RFQ NUMBER
708EC005

ADDENDUM #1

9 CUBIC YARD STAINLESS STEEL (HYDRAULIC) SPREADER

CHANGES TO SPECIFICATIONS:

Wiring Code 7 way Trailer End

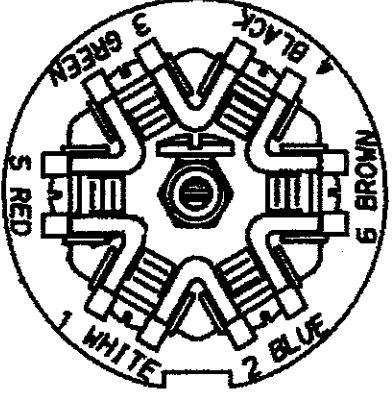
7.10 Lighting to be in accordance with the attached sketch.

7.10 Lighting to be in accordance with the attached sketch and wiring schematic

#	Color	Gage	Circuit Function	connector interior
1	white	10	common ground	
2	blue	12	<i>STROBE</i>	
3	green	14	tail/running lights	
4	black	10	battery charge (+)	
5	red	14	left turn/stop	
6	brown	14	right turn/stop	
7	yellow	14	auxiliary/ <i>Work LIGHTS</i>
